City of Phoenix

ADDENDUM A

Staff Report Z-22-18-2

Desert View Village Planning Committee Meeting Date:	October 2, 2018
Planning Commission Hearing Date:	November 1, 2018
Request From:	C-1 (5.12 acres)
Request To:	PUD (5.12 acres)
Proposed Use:	Planned Unit Development to allow self-storage and commercial uses
Location:	Approximately 290 feet south and 490 feet west of the southwest corner of Tatum Boulevard and Dynamite Boulevard
Owner:	P & G Properties, LLC
Applicant/Representative:	Wendy Riddell, Berry Riddell, LLC

LANDSCAPE PLAN
SCALE: 1" = 30'-0"

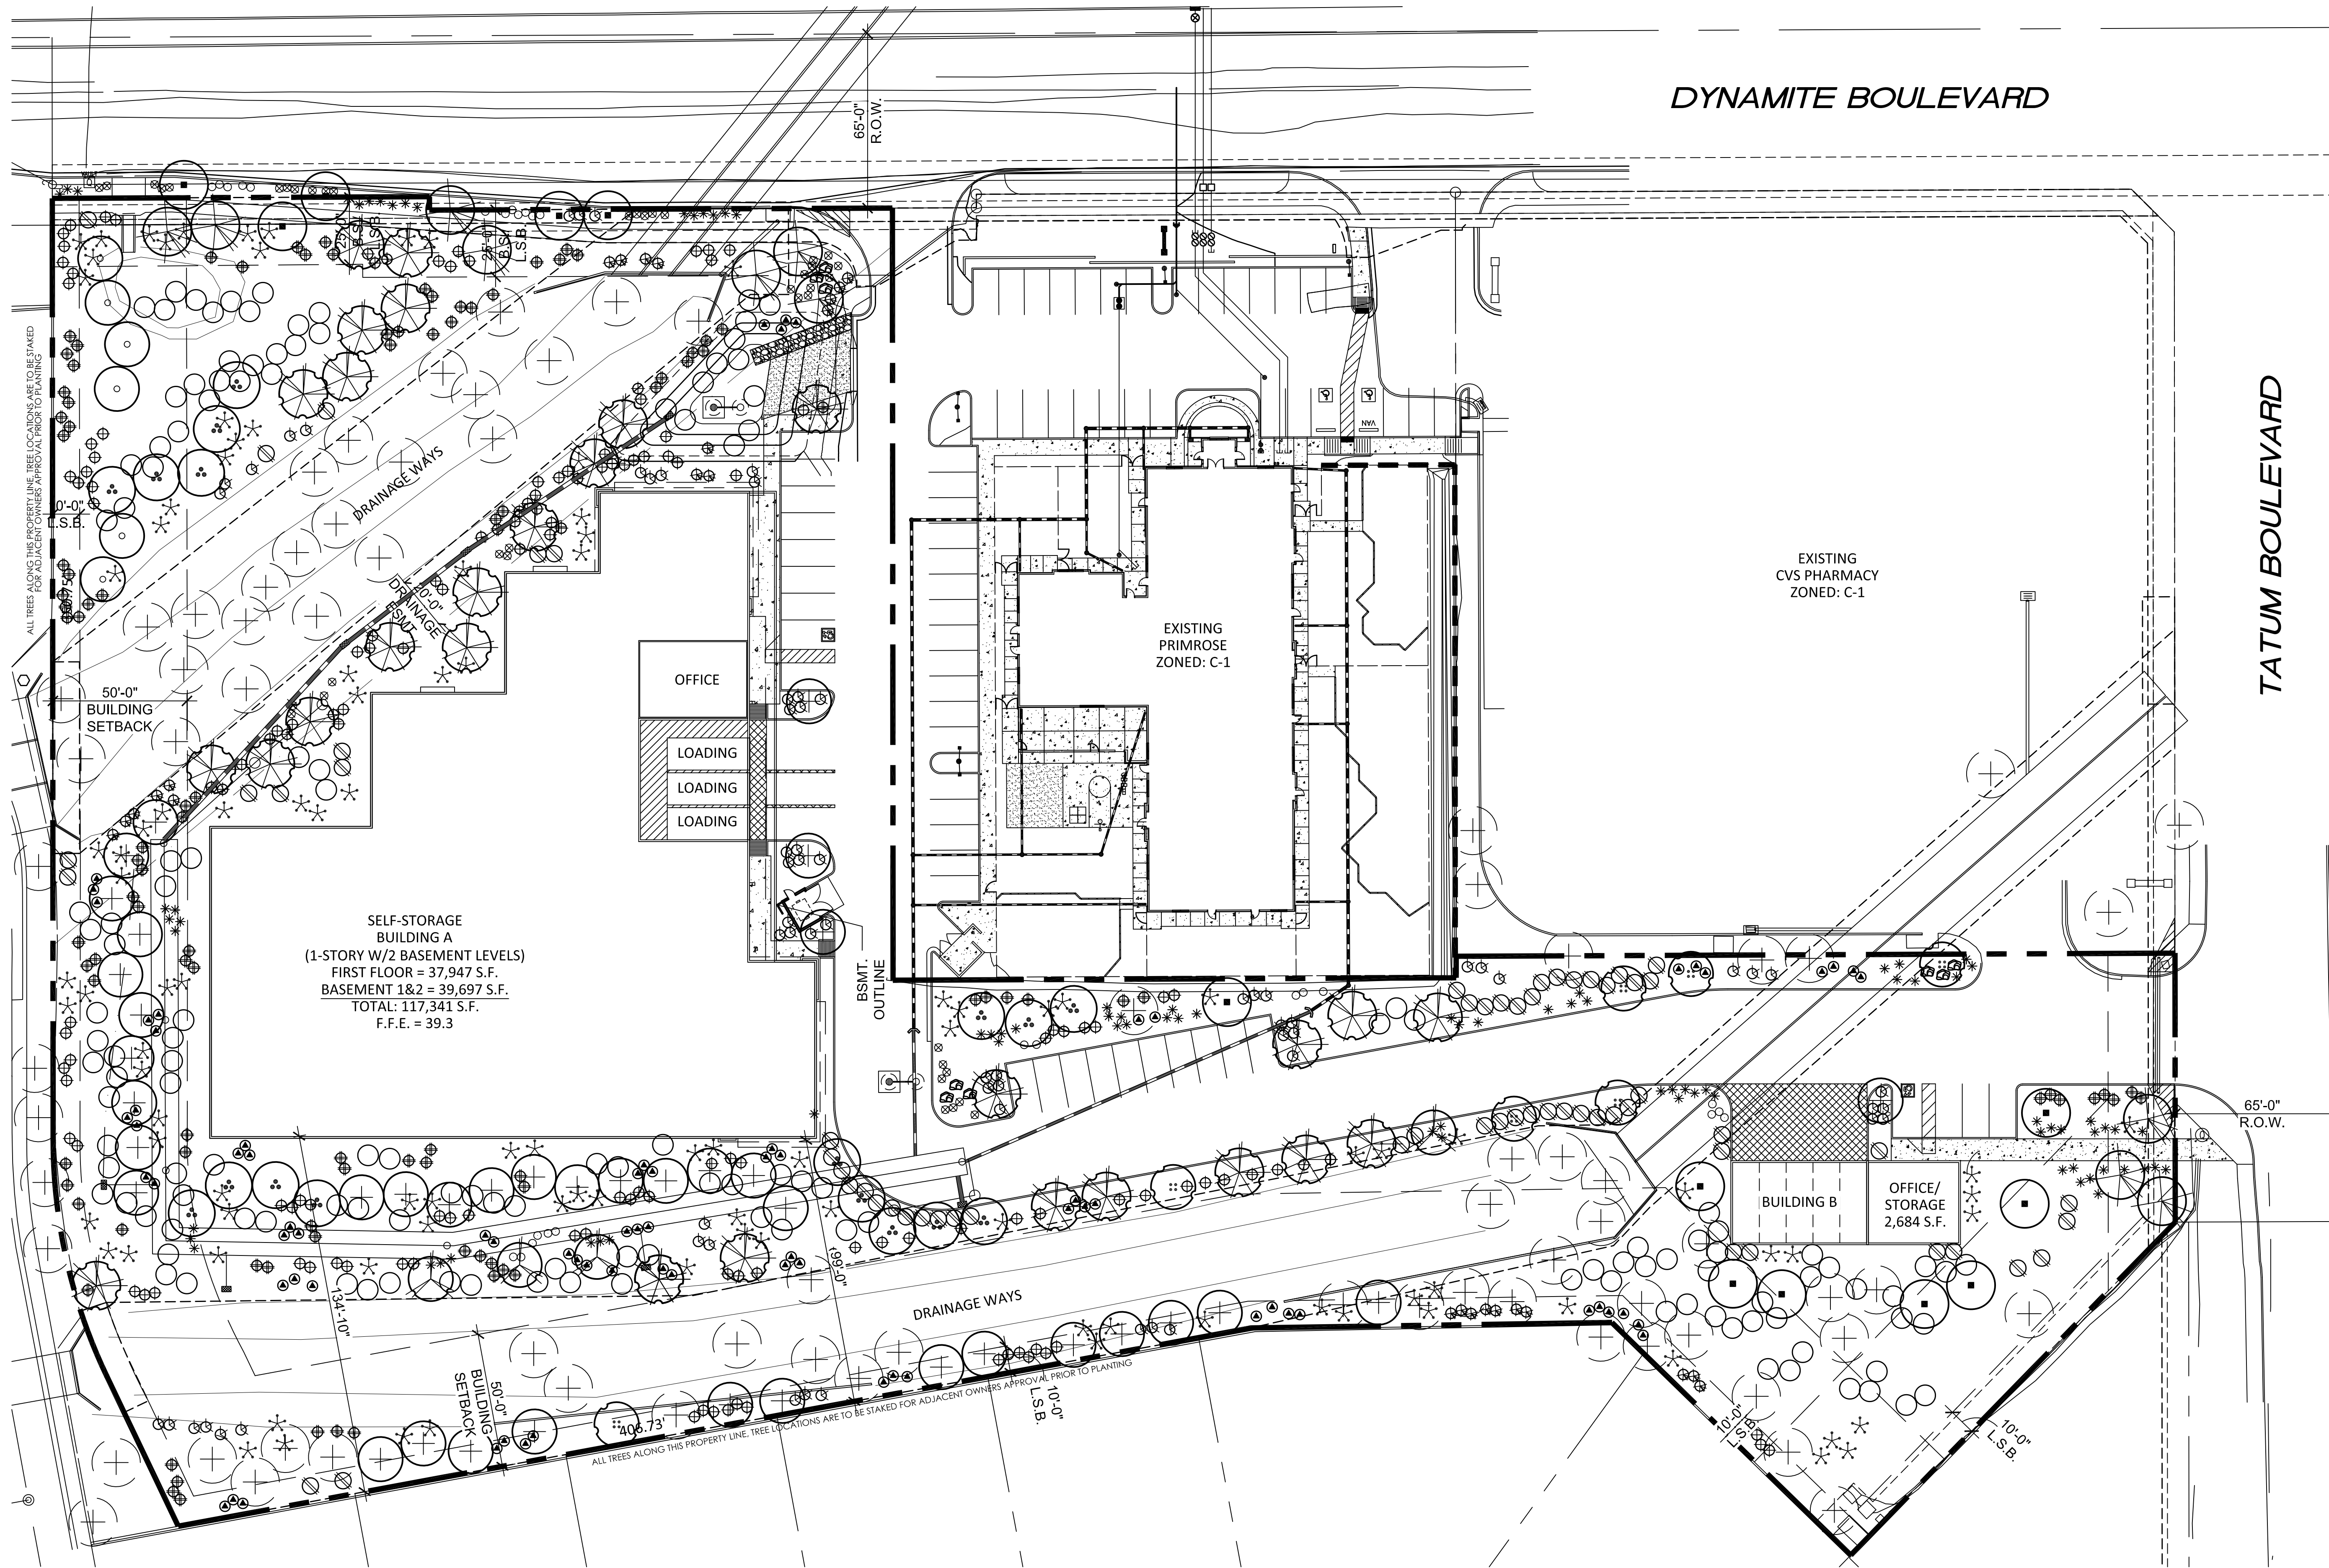
- a. AN UPDATED LANDSCAPE PLAN DATE STAMPED OCTOBER 31, 2018 SHALL BE ADDED AS EXHIBIT D.
 - b. PAGE 14-15, LANDSCAPING STANDARDS, THE FOLLOWING SHALL BE ADDED:

5. THE DEVELOPMENT SHALL BE IN GENERAL CONFORMANCE TO THE LANDSCAPE PLAN DATE STAMPED OCTOBER 31, 2018, EXCLUSIVE OF TREES SHOWN IN DRAINAGE WAYS, AS APPROVED BY THE PLANNING AND DEVELOPMENT DEPARTMENT.

6. ALL LANDSCAPING ALONG THE SOUTHERN PROPERTY LINE, SOUTH OF THE WASH, SHALL BE INSTALLED PRIOR TO THE ISSUANCE OF ANY BUILDING PERMIT, AS APPROVED BY THE PLANNING AND DEVELOPMENT DEPARTMENT.

- i. STREETScape (NORTH), EXCLUSIVE OF DRAINAGE WAYS SHALL PROVIDE 1 TREE AND 5 SHRUBS FOR EVERY 20 LINEAR FEET OF STREET FRONTAGE, 20-FOOT ON CENTER OR EQUIVALENT GROUPINGS.

- ii. STREETScape (EAST), EXCLUSIVE OF DRAINAGE WAYS SHALL PROVIDE 1 TREE AND 5 SHRUBS FOR EVERY 20 LINEAR FEET OF STREET FRONTAGE, 20-FOOT ON CENTER OR EQUIVALENT GROUPINGS.

- iii. PERIMETER LANDSCAPE SETBACK (EXCLUSIVE OF STREETScape STANDARDS AND DRAINAGE WAYS) SHALL PROVIDE 1 TREE AND 5 SHRUBS FOR EVERY 15 LINEAR FEET OF PROPERTY LINE, 20-FOOT ON CENTER OR EQUIVALENT GROUPINGS.

- iv. ALL LANDSCAPE AREAS OUTSIDE OF REQUIRED LANDSCAPE SETBACKS, EXCLUSIVE OF DRAINAGE WAYS SHALL PROVIDE 1 TREE AND 5 SHRUBS FOR EVERY 800 SQUARE FEET OF LANDSCAPE AREA.
